**Response to Notice of Deficiencies #1, Coyote Basin Project, File No. P-2025-011, 25-08-01**

**Subject:** Re: Notice of Deficiencies #1, Coyote Basin Project, File No. P-2025-011

Coyote Basin  
Property 2025  
Program

Figure 10

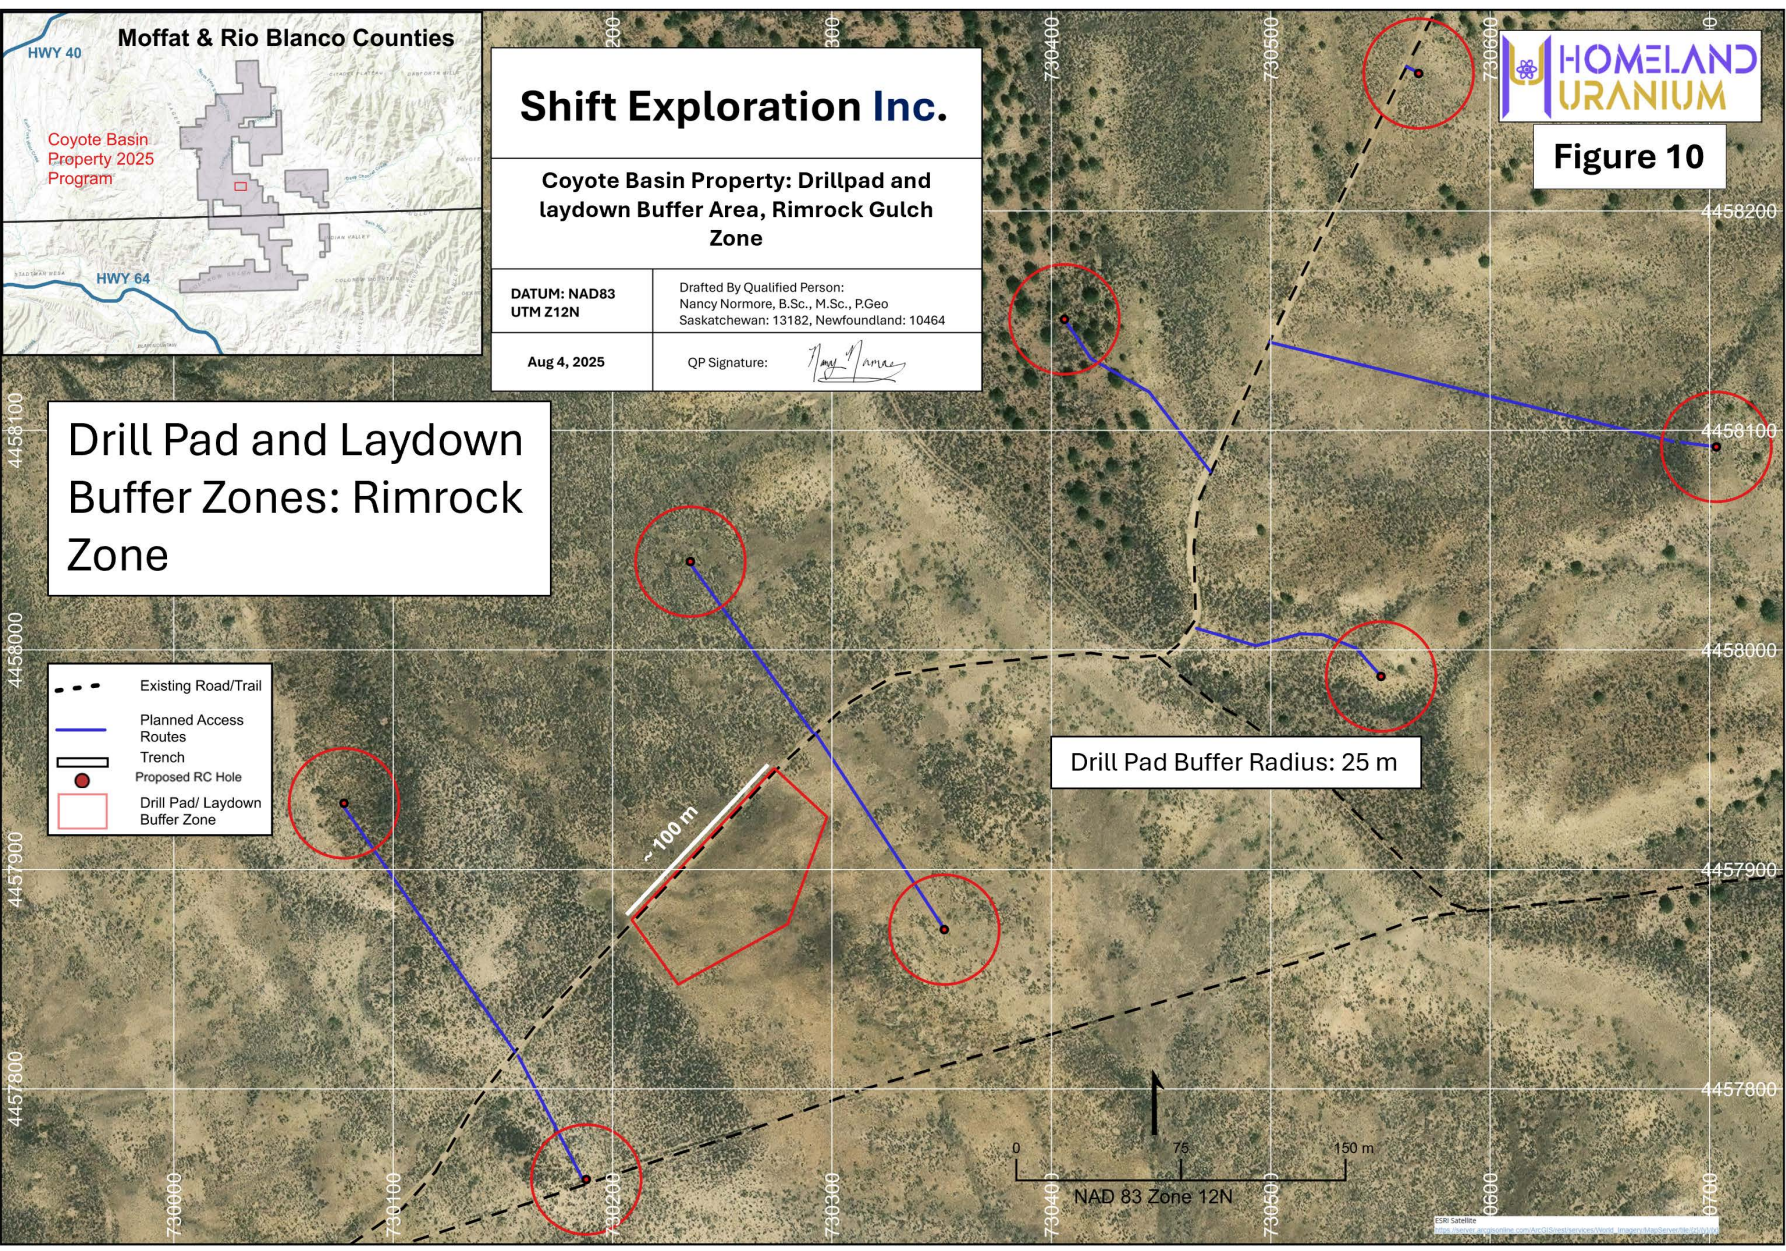
6. The type of mix will be provided by BLM. SEI-HLU will use the appropriate seed mix as directed by BLM.
7. Trenches, Drillpad and Laydowns Areas:
  - The Trenches will be a maximum of 5 ft deep and will approximately excavate 315.4 cubic yards or less. Topsoil will be stored immediately adjacent to the trench. Trench dimensions are 131 x 6.6 ft without topsoil. With topsoil storage, affected area is 131 x 13 ft. See Figures 2-13 provided.

- Maximum depth for sump will be 5 ft. Typical sump size will be 4ft x 8ft by 5 ft deep. Topsoil will be stored within the drillpad area of 30 x 50 ft, within the immediate area of the sump (as long as deemed safe). See Figures 2 – 13.

- Laydown areas will have no excavated material. These are intended to be left undisturbed. Laydowns are chosen in areas of low to no vegetation. See Figures 2 – 13.
